**Subject:** DA2020/0941 and DA2020/0900

DA NO: 2020/0900 and 2020/0941

PROPOSED: CONSTRUCTION OF A NEW DWELLING ON PROPOSED LOT 1 AND LOT 2

PREMISES: 4 CAMBRIDGE AVENUE, NARRAWEENA

Extract of Tree Location Map from Arborist Report submitted with original subdivision, identifying Tree 12.

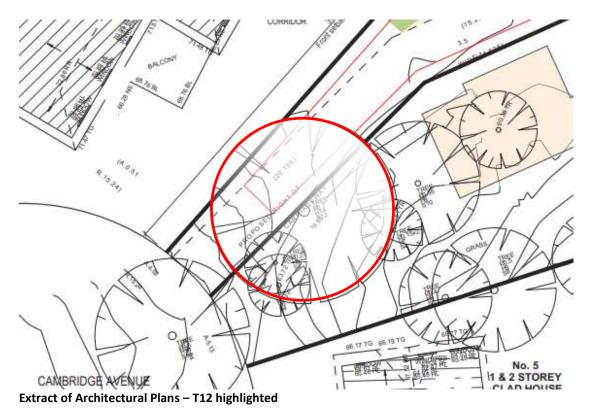
Tree 12 (Angophora costata – Sydney red gum) is located immediately adjacent to the driveway and we have concerns over the potential impact of the construction of and location of the driveway on this tree. This application has not been supported by an arborist report as would be expected. Further the driveway plan submitted (prepared by Taylor Consulting) does not depict any trees.

It is considered that the application is lacking considerable detail and information as would normally be required.
